## RESPONSE TO REQUEST FOR ADDITIONAL INFORMATION

### APR1400 Design Certification

Docket No. 52-046

RAI No.: 182-8160  
SRP Section: 03.07.01 – Seismic Design Parameters  
Application Section: 3.7.1  
Date of RAI Issue: 08/31/2015

Figure 42 Comparison of Minimum-Required Target PSD for Horizontal Time History and PSD of Time History of Truncated Duration from 3.0 sec to 10.5 sec for HRHF-EW

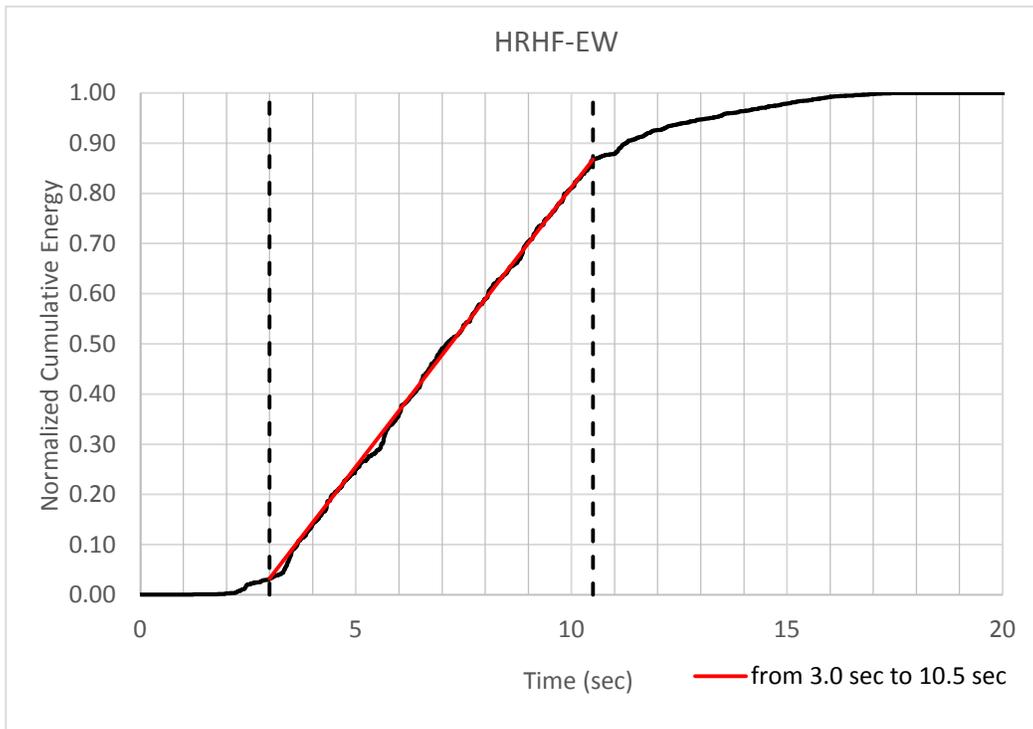
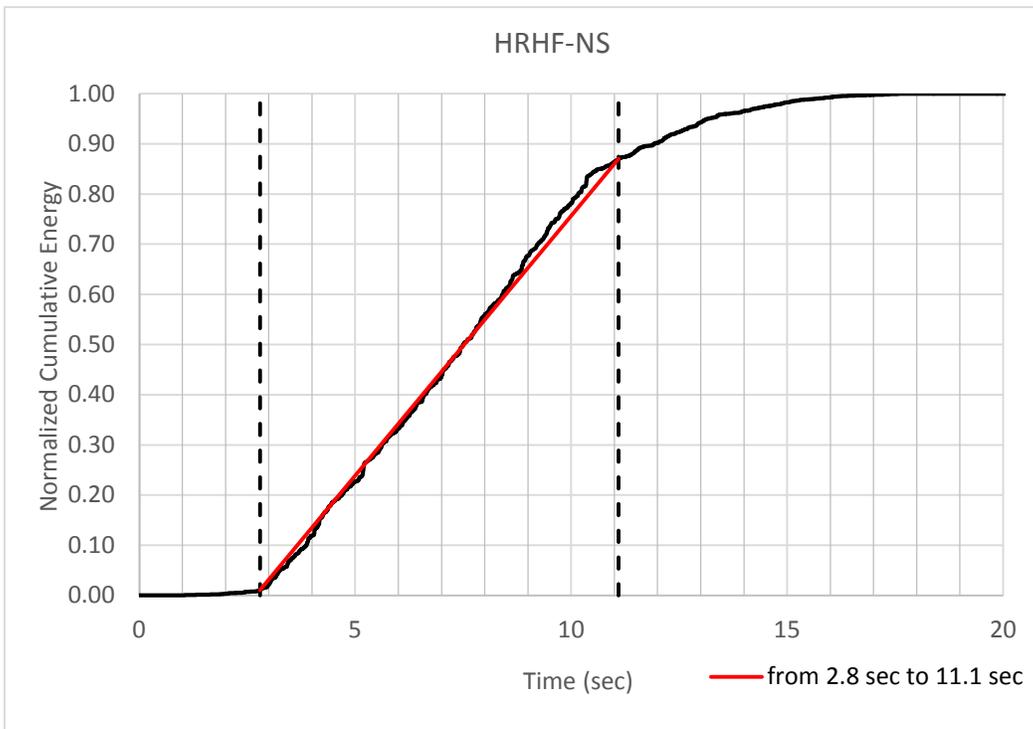
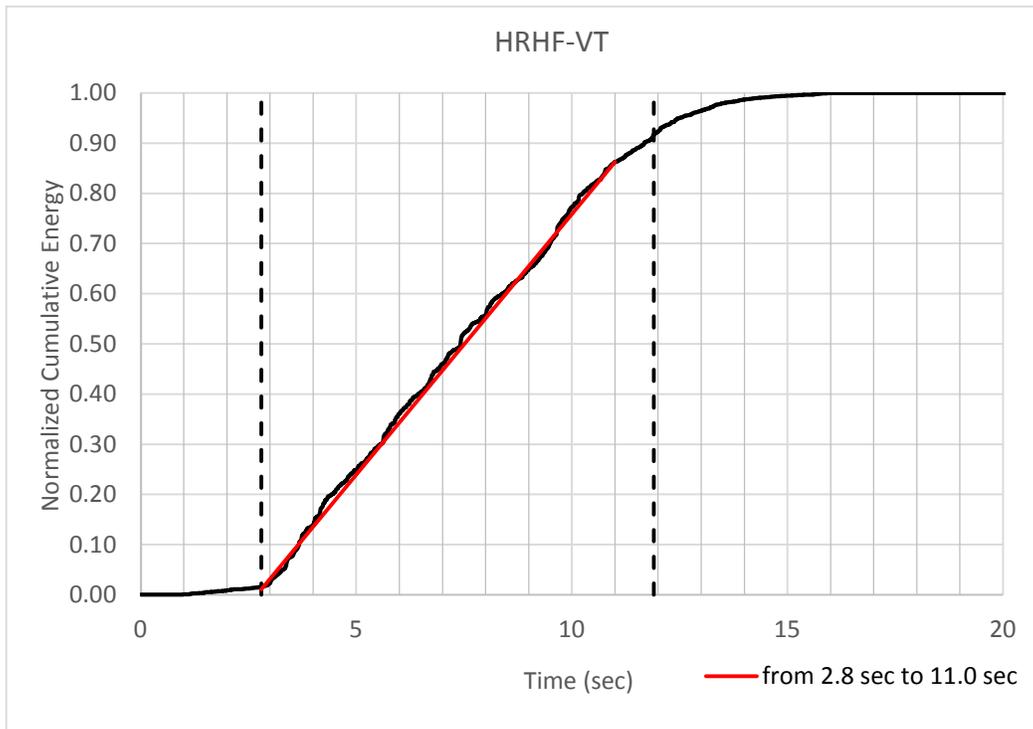
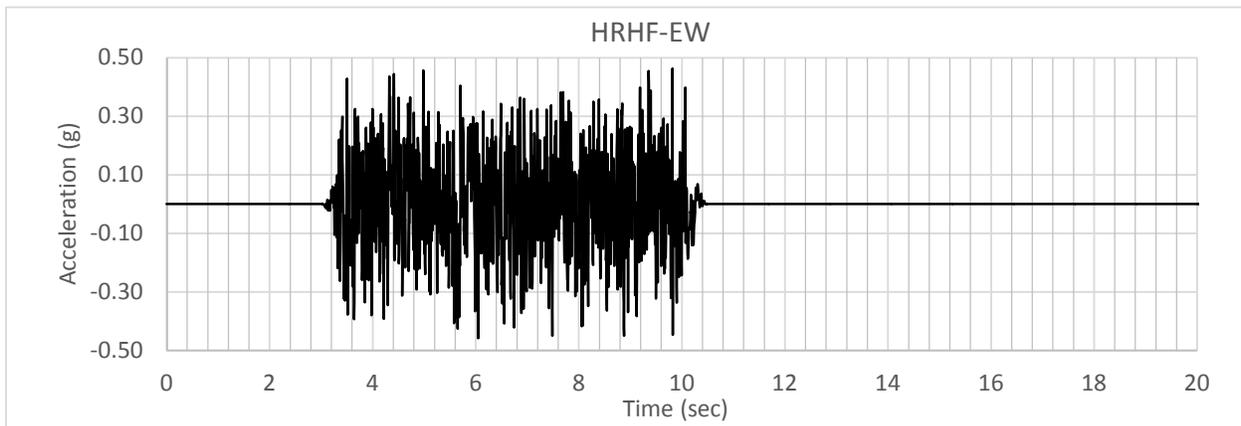
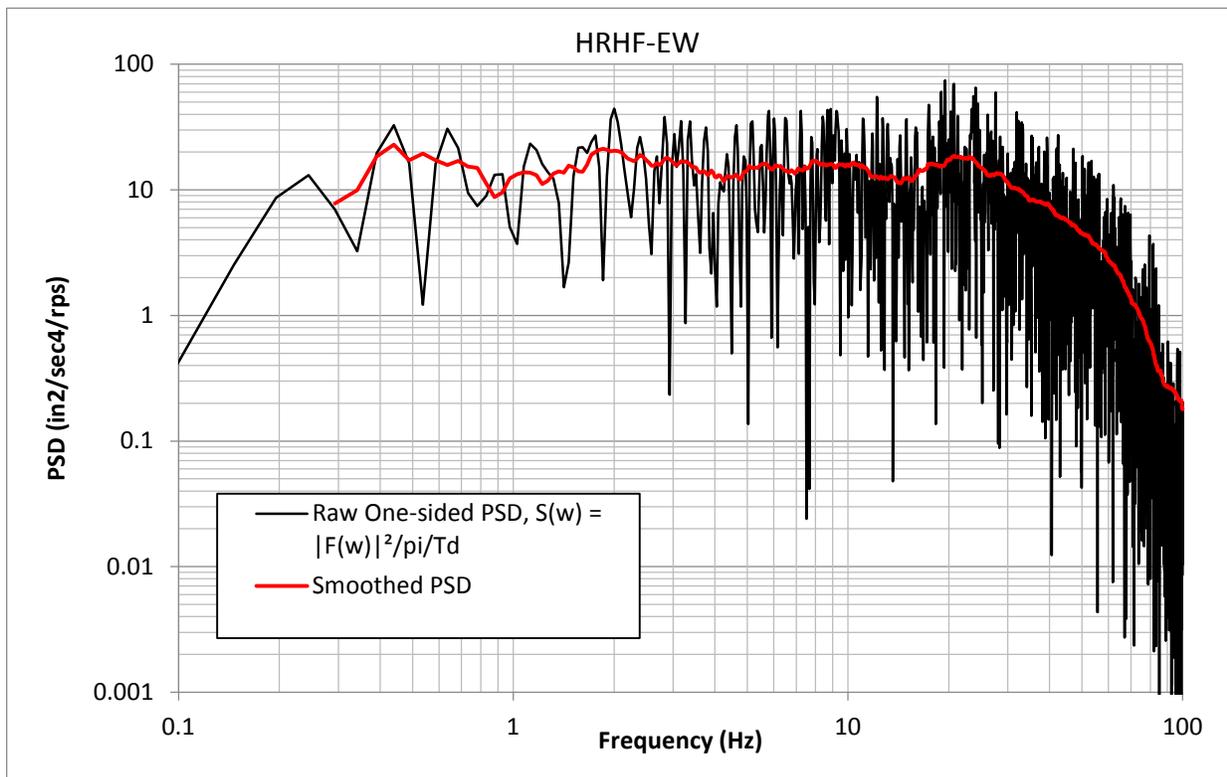
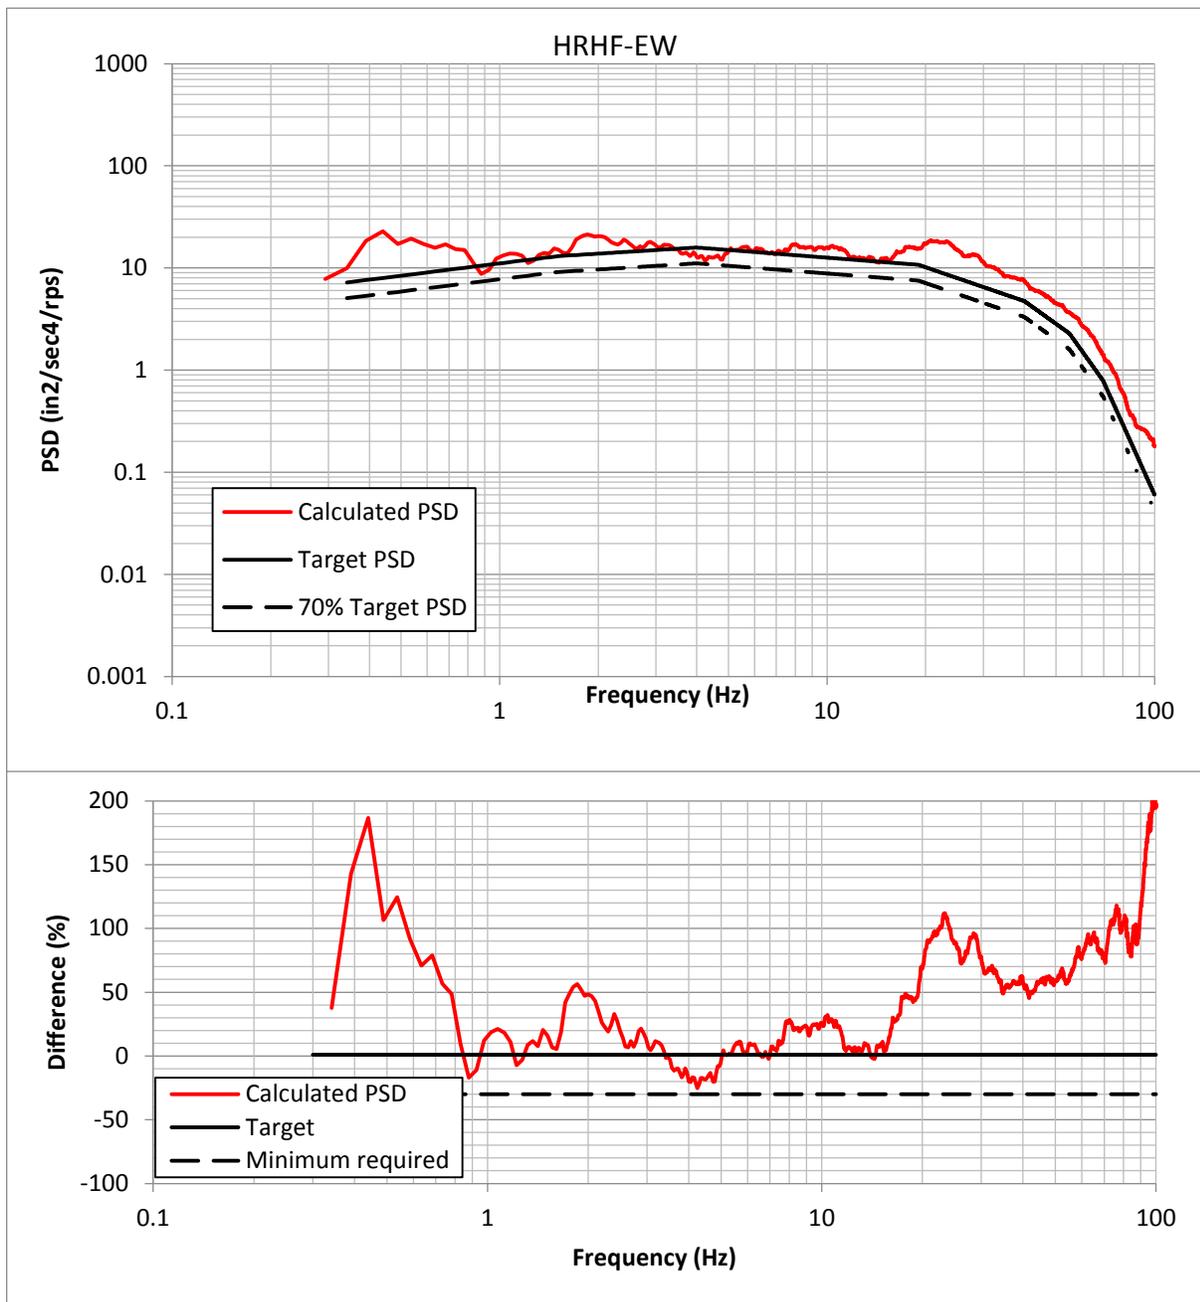
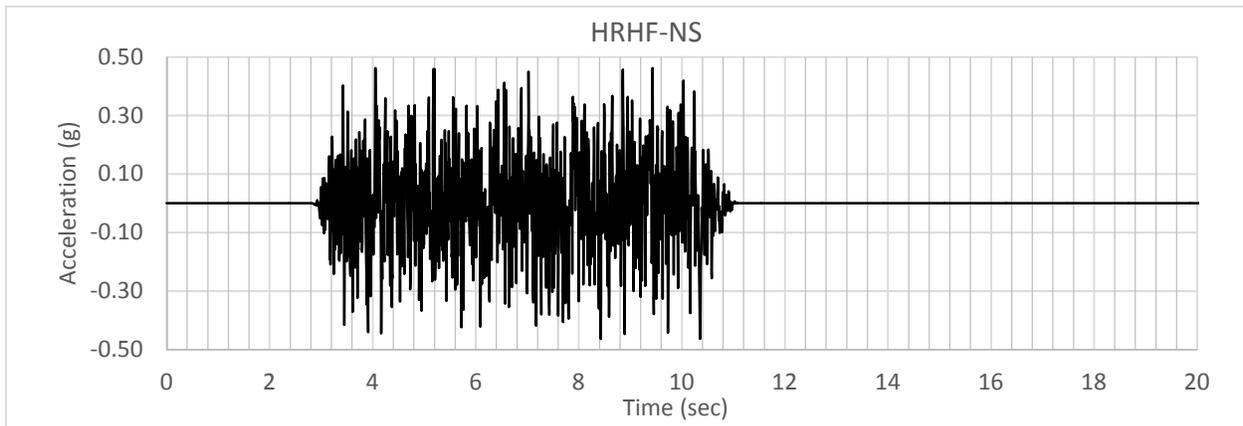
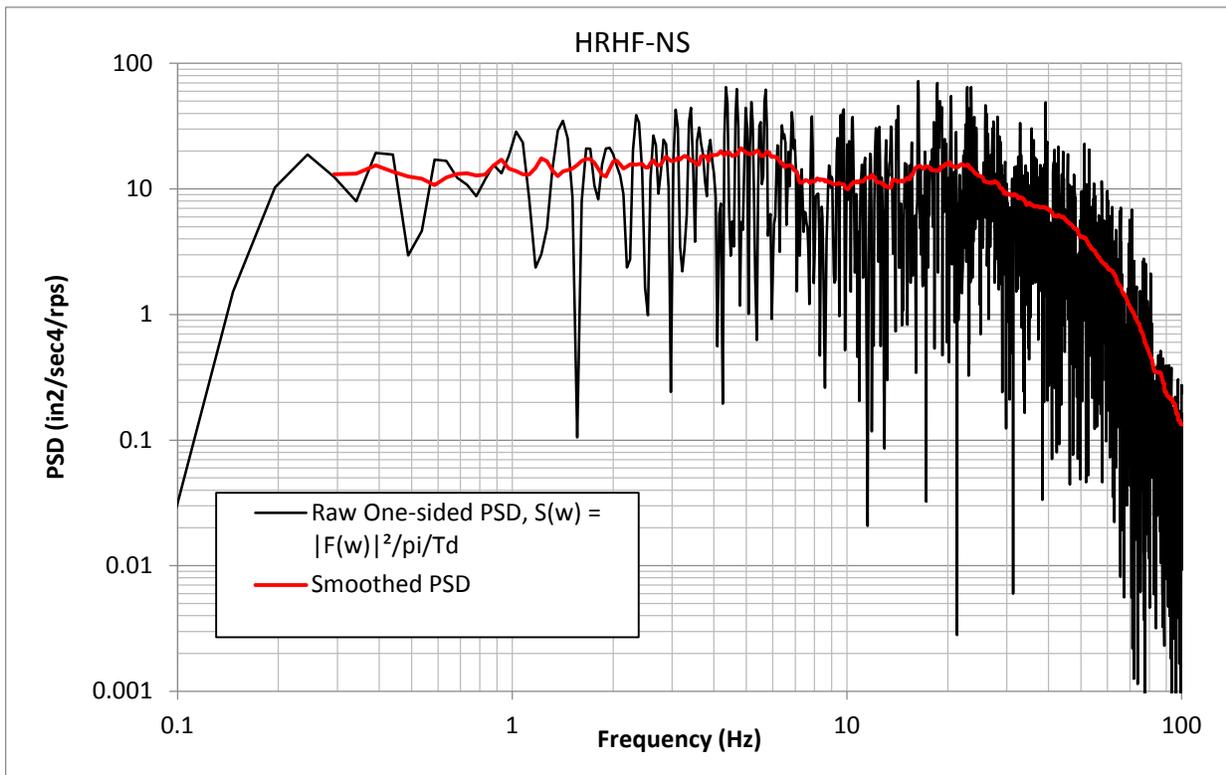
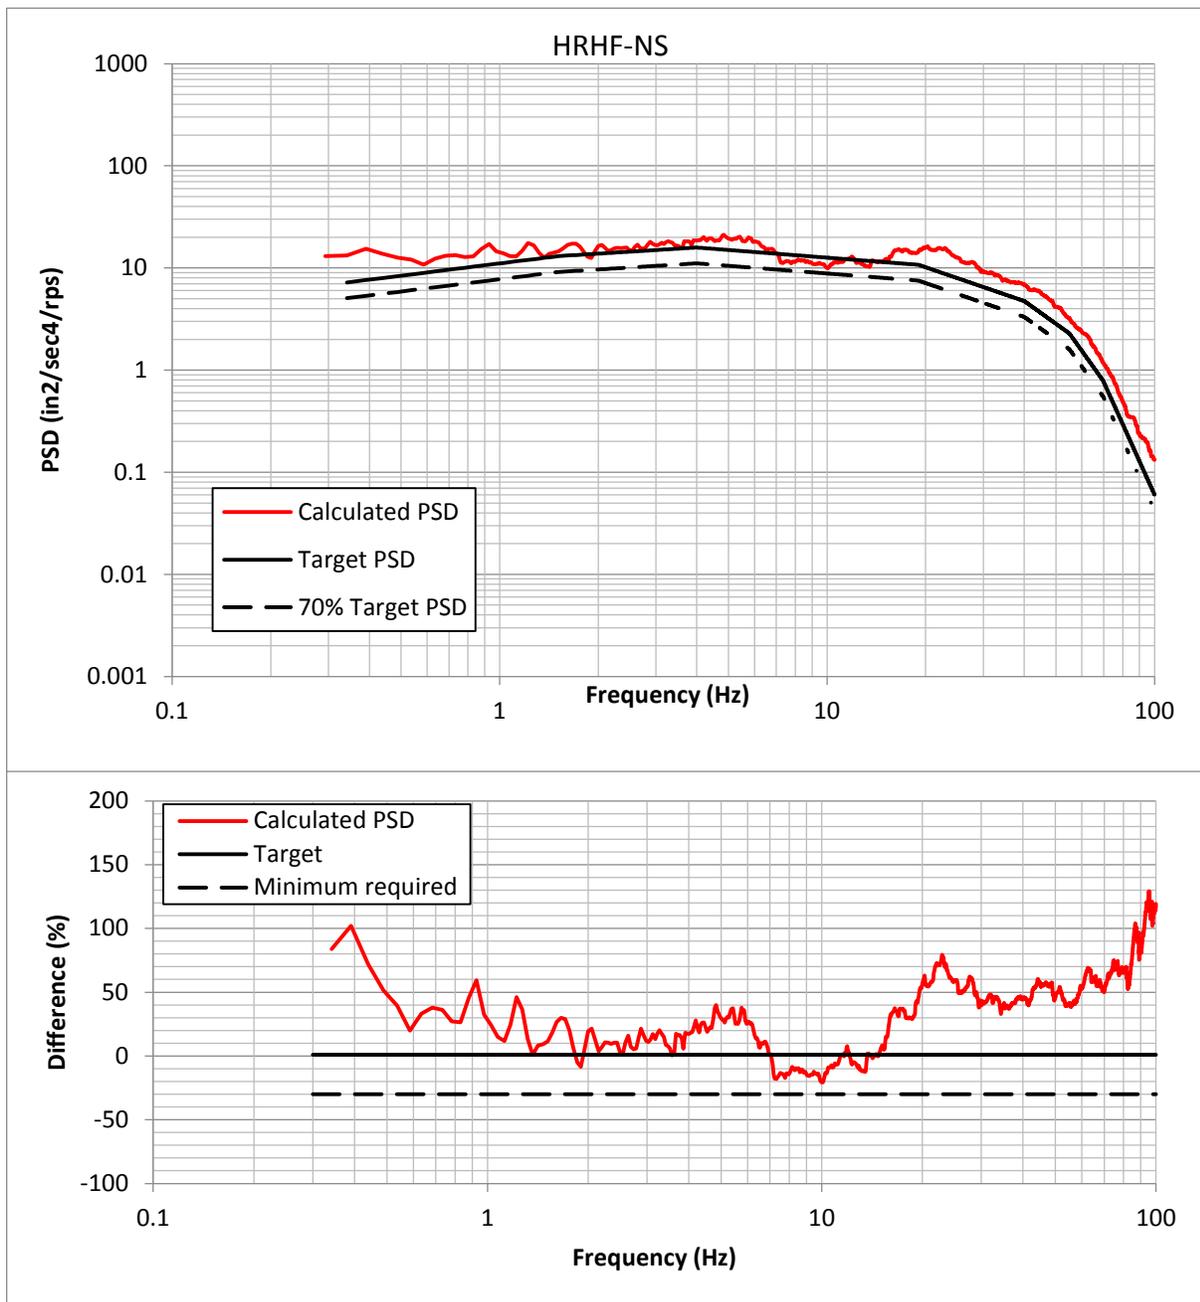
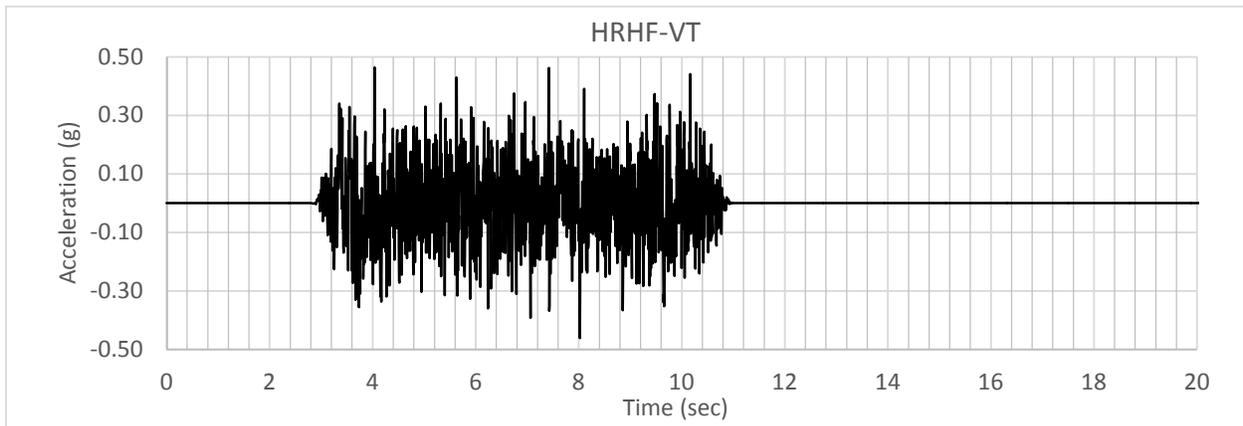
**b) Justification of the method used to estimate PSD for the HRHF time histories**

Section 3.5.3 of APR1400-E-S-NR-14004-P, Rev. 1, "Evaluation of Effects of HRHF Response Spectra on SSCs," describes the method used to calculate the PSD function from an acceleration time history. It utilizes an "equivalent stationary strong-motion duration" as the strong motion duration. The equivalent stationary strong motion is defined as the time for a P1-to-P2 rise of the cumulative Arias intensity, divided by (P2-P1). The applicant stated, "the equivalent stationary duration  $T_{is}$  for the entire time histories as determined from Eq. (3-3) is the duration over which the total energy of the time history is built up from 0 to 100 percent with the

constant slope S.” In this statement, the parameters P1, P2, and S are not defined. As such, the applicant is requested to provide these three parameters for the three HRHF acceleration time histories. In addition, it appears that the PSD estimate is very sensitive to the choice of P1 and P2; for example a P1=0 and P2=100% will lead to an equivalent stationary strong-motion duration  $T_s$  equal to the total duration of the time history. As such, the applicant is also requested to provide a justification for the values of P1 and P2.

Appendices A and B of SRP 3.7.1 indicate that PSD should be estimated based on the strong motion duration. Therefore, the staff requests that the applicant provide a justification for the use of equivalent stationary strong-motion duration. Similarly, the applicant is requested to explain why the entire time histories were used in the Fourier transform. The use of the equivalent stationary strong-motion duration, which is shorter than the entire duration as shown in Figure 3-27 of APR1400-E-S-NR-14004-P, Rev. 1, together with the entire time history used in the Fourier transform, may overestimate the PSD for those frequencies that have very low magnitude but span the entire time history

The PSDs for the HRHF RS compatible time histories are computed using the procedure which is described in response to Question 03.07.01-3 (a) as shown in Figure 37 through 48. The PSDs for the HRHF RS compatible time histories satisfy requirement of Appendix B of SRP 3.7.1, Rev. 4 as shown in Figure 42, 45, and 48.
